**APPLICATION NO. A/NE-TK/837 FOR PERMISSION  
UNDER SECTION 16 OF THE TOWN PLANNING ORDINANCE**

Annex 1 - Response to Comments Table

Section 16 Application for Temporary Public Vehicle Park (Private Cars Only) with Ancillary Electric Vehicle Charging Facilities and Ancillary Solar Panels and Associated Filling of Land for a Period of 3 Years at Lot No. 241 in D.D. 23 at Ting Kok, Tai Po, New Territories

# Annex 6

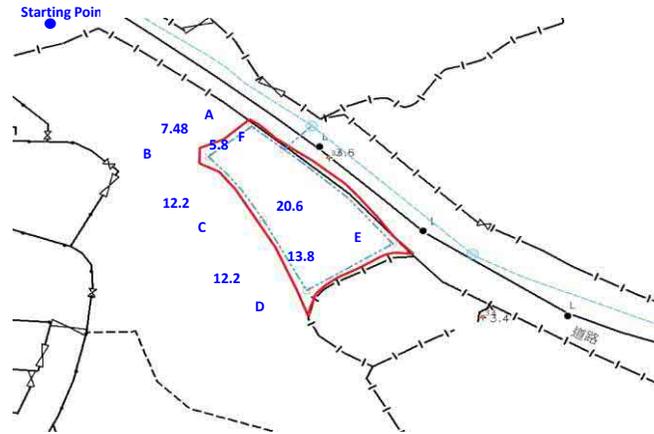
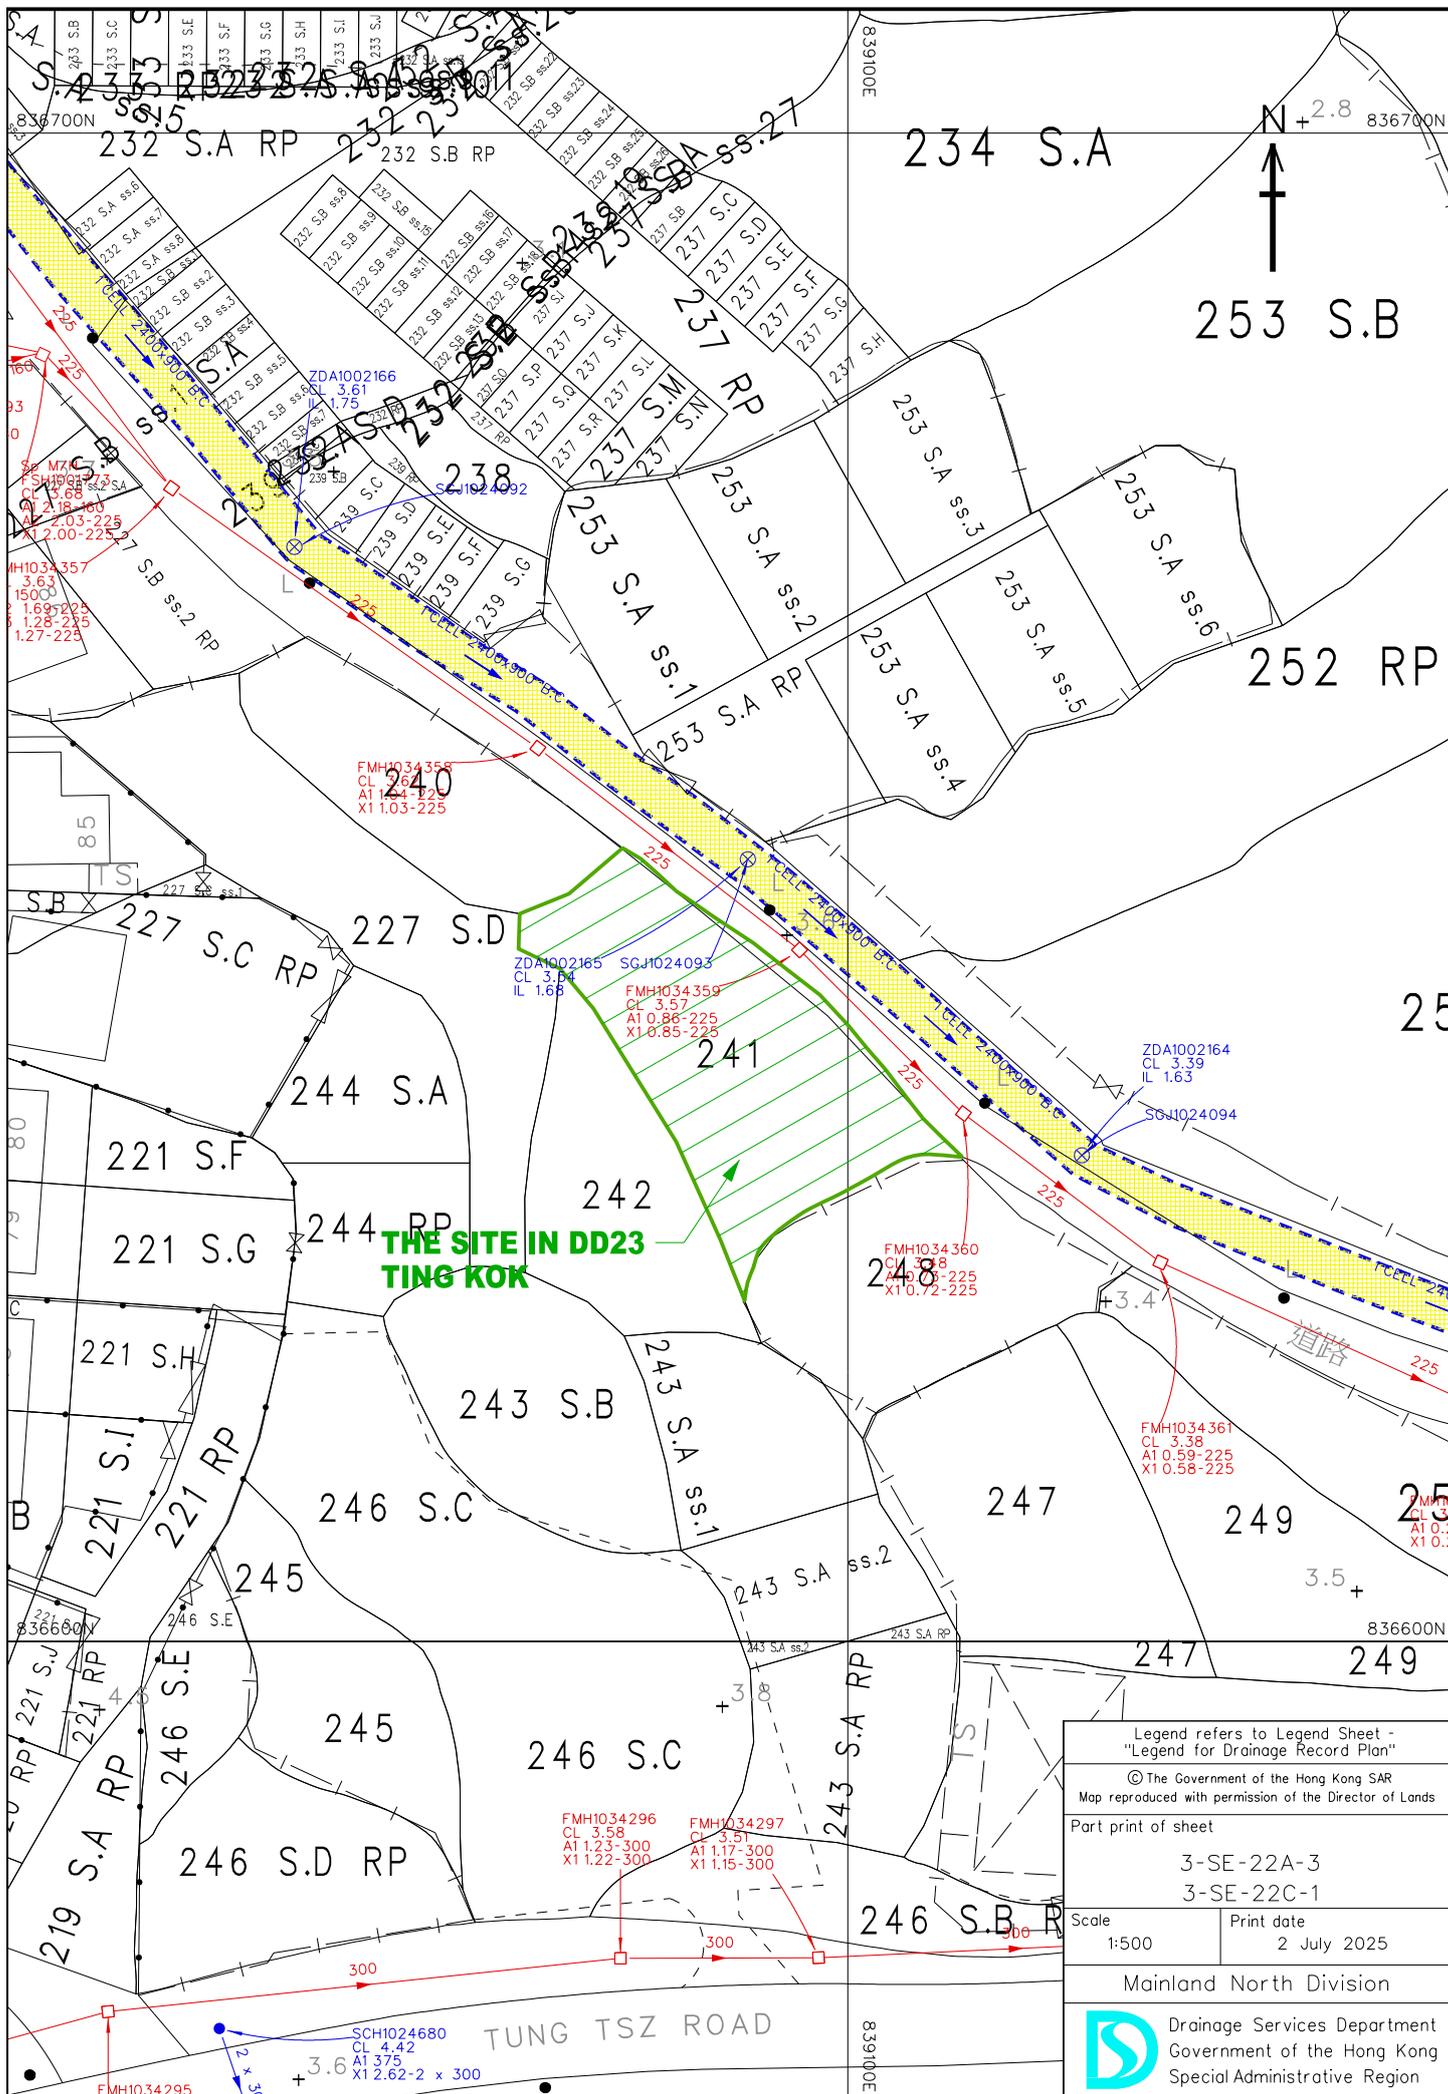
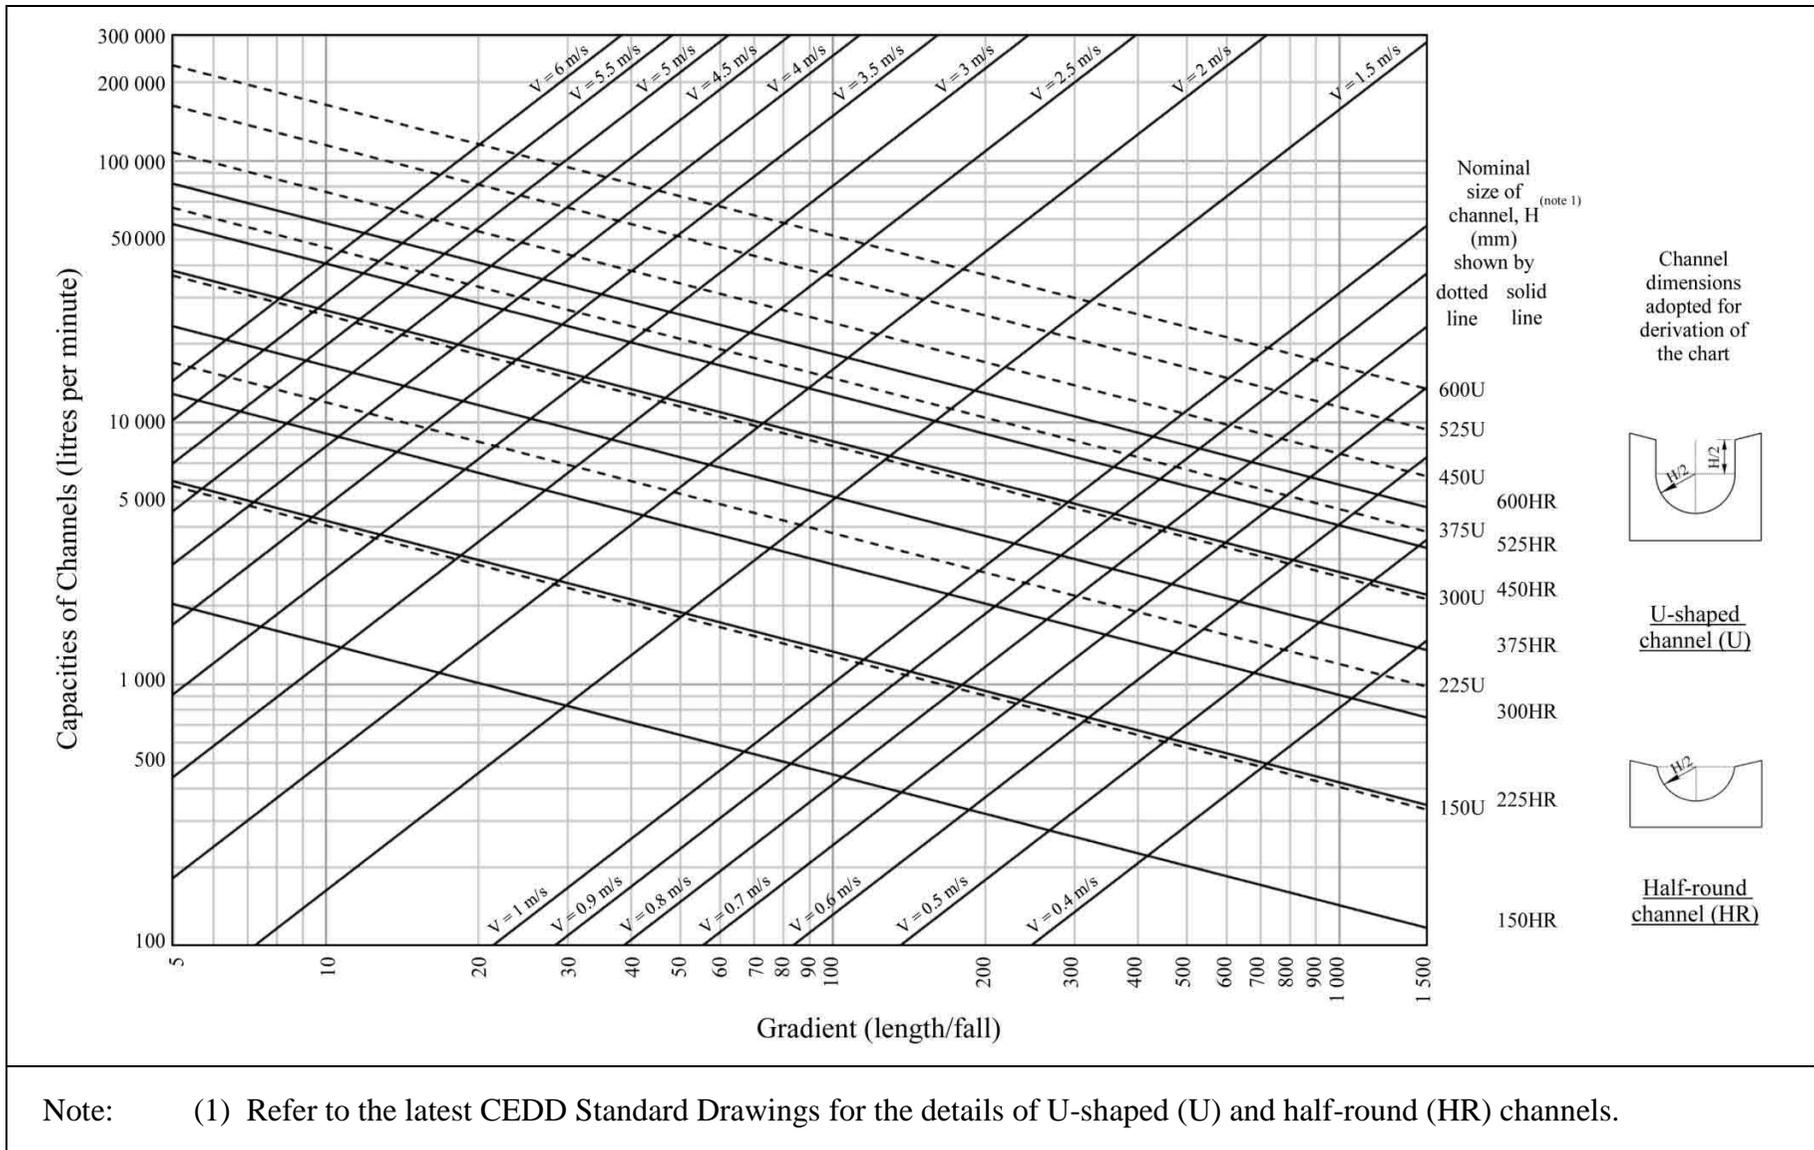
j	2. As such, the applicant is required to provide further information to demonstrate that the development will not cause adverse drainage impact to the adjacent areas.	A drainage proposal is attached in <b>Annex 6</b> to demonstrate that the Proposed Development would not have adverse drainage impact onto the surrounding lands and premises.
k	3. While there are DSD's public stormwater drains in this area, the applicant should have its own stormwater collection and discharge system to cater for the runoff generated within the Site and overland flow from surrounding of the Site, e.g. surface channel of sufficient size along the perimeter of the Site; sufficient openings should be provided at the bottom of the boundary wall/ fence to allow surface runoff to pass through the Site if any boundary wall/ fence are to be erected Any existing flow path affected should be re-provided. The applicant should neither obstruct overland flow nor adversely affect the existing natural streams, village drains, ditches and the adjacent areas. The applicant is required to maintain the drainage systems properly and rectify/modify the	Well noted with thanks.
